**CITY OF HUTTO, TEXAS  
ZONING BOARD OF ADJUSTMENT  
REGULAR MEETING  
AUGUST 22, 2018 AT 7:00 PM  
CITY HALL – COUNCIL CHAMBERS  
401 W. FRONT STREET**

Consideration of a public hearing and possible action on variance request #1.41 for the property located at 300 Ed Schmidt Boulevard, to reduce the percentage of required glazing on a building, as outlined in Section 10.406.6.4.8 of the Unified Development Code (UDC).

**FROM:** Ashby Grundman, Director of Planning  
**TO:** Zoning Board of Adjustment  
**SUBJECT:** Item #1.4I- 300 Ed Schmidt Boulevard – Site Design Transparency

**RE: Jason's Deli – Hanson's Corner – Pad Site 4, Hutto, TX –  
Nature of Request Letter & Review Criteria (Findings) Responses**

A-201c

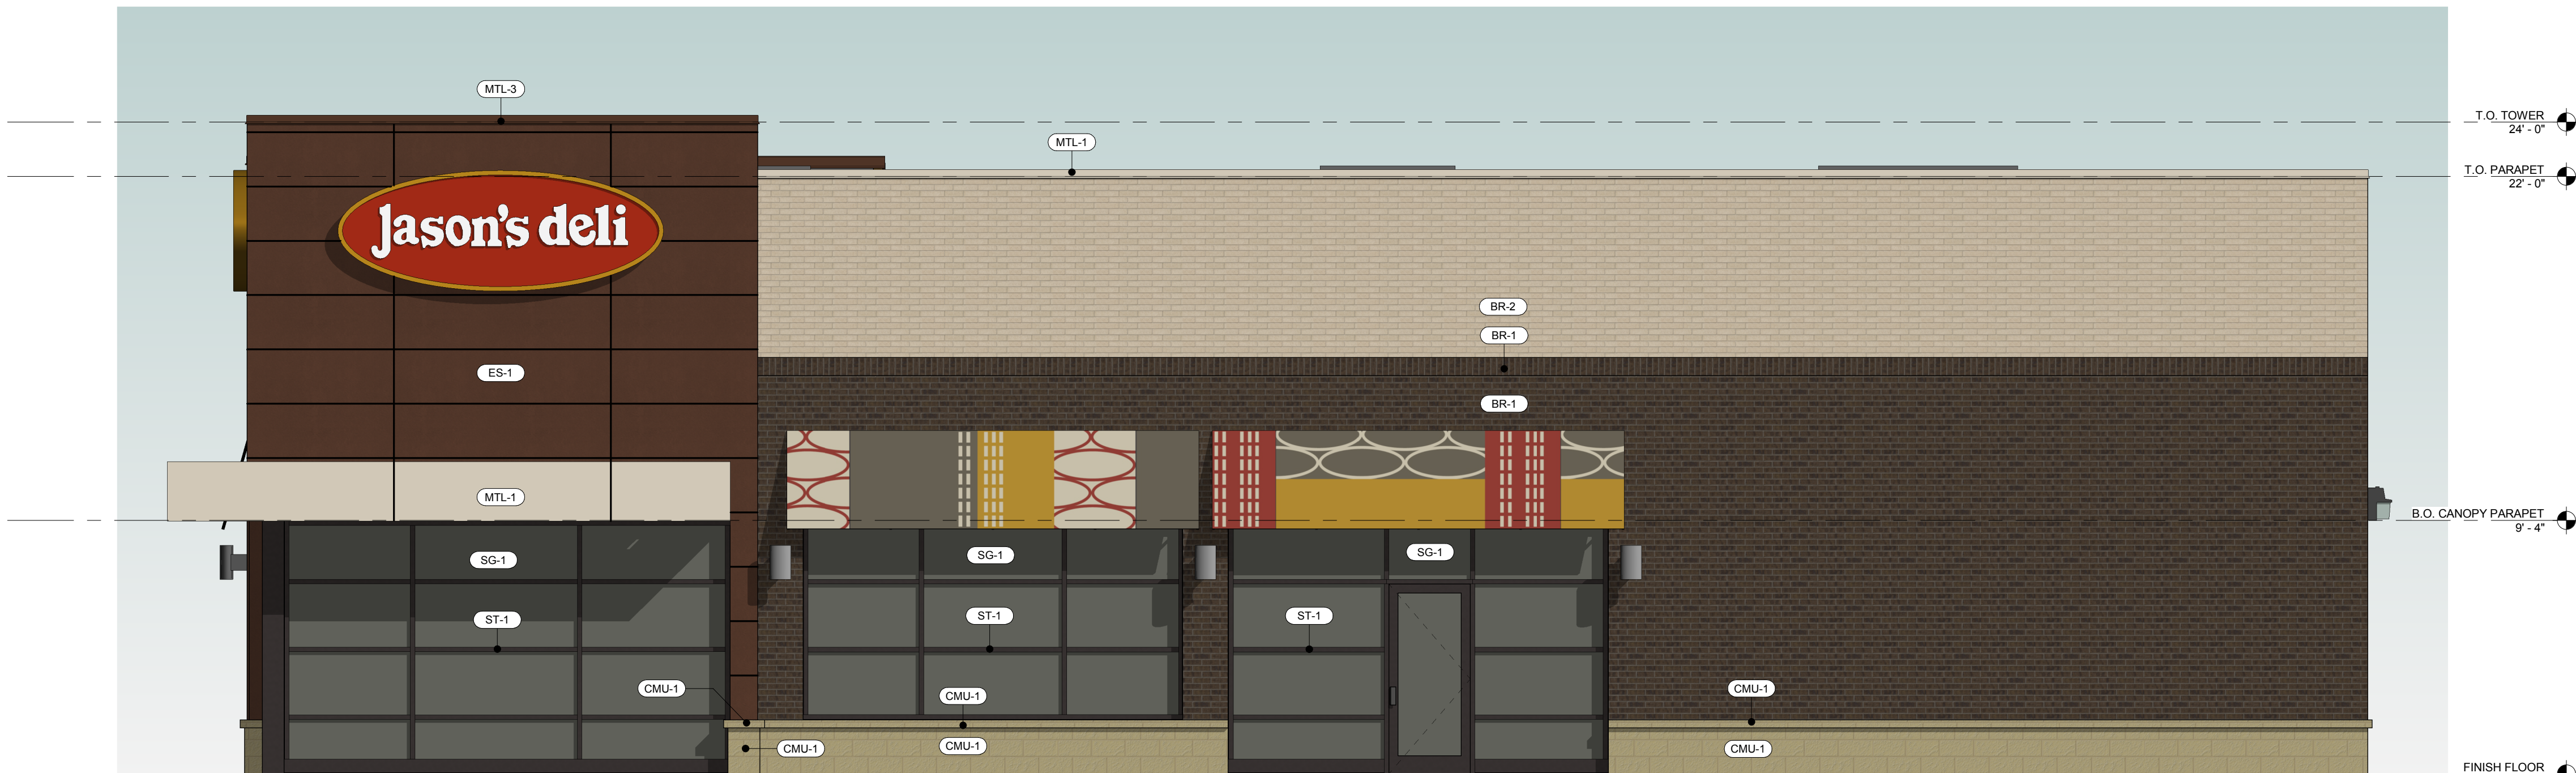
They are requesting a variance to allow them to provide less than the required glazing for the side elevation. They are proposing 45'-9 1/2", which is about 14 feet less than the required 58'-7" per the UDC. In addition to that, along the front elevation of the building they are proposing to have 18.8% of their glazing be opaque, which brings their proposed glazing to 37'-7", as opposed to the 46'-2" required by the UDC. They have provided the required glazing on the drive-thru side of the building.

The applicant has requested a reduction in the required transparency requirements on the front and side of the proposed building. Staff finds that the proposed 14 foot reduction on the side and proposed 18.8% opaque glazing on the front do not meet the minimum necessary to grant relief. There are alternatives set

On the front of the building (elevation 1 on A-201c), the required glazing length is 46'2". We are able to meet this, although 18.8% of this glazing will be opaque. The farthest left window opening is in the kitchen area, where the to-go orders are processed. We cannot have customers viewing into the kitchen. There is no way to modify the kitchen and still provide a to-go order service, and therefore we ask that this percentage of opaque glazing be included in the total glazing requirement for the front façade.

On the side elevation which has exposure to the dining room (elevation 2 on A-201c), the required glazing length is 58'7". We are able to provide 45'9 1/2" (58%), which is 14' (17%) short of the requirement. We significantly modified our building structure and expanded the window openings as much as we can. Beyond the farther right window are restrooms and kitchen, and therefore we cannot provide window openings. We have made every effort to comply, but the building use will not allow 75% glazing. There are other buildings in this development which also do not comply, and share a similar use (Taco Bell).

Staff finds that the requested variance does not present a unique or undue hardship. The requested variance is design driven. The recommended alternatives for compliance were provided to the applicant, but the applicant chose to proceed with the variance.
